Category Vehicle Interior

Section Seat Market USA

YEAR(S) MODEL(S)		ADDITIONAL INFORMATION		
2016 - 2019	RX350, RX450H

Some 2016 – 2019 model year RX350 and RX450h vehicles may exhibit a condition where there is a noticeable seat heater temperature difference between the driver and/or passenger seats. Follow the Repair Procedure in this bulletin to address this condition.

Figure 1.

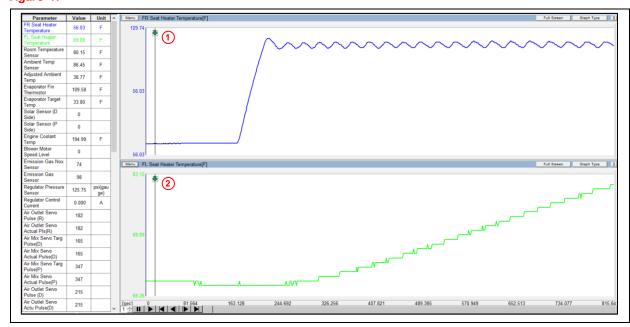
When the seat heater is turned on, does the signal increase sharply and reach up to 120°F?

1 Correct Seat Heater Operation (Sharp Increase to 120°F)
2 Incorrect Seat Heater Operation

4. Replace the seat heater element that is functioning incorrectly according to the results of step 3.
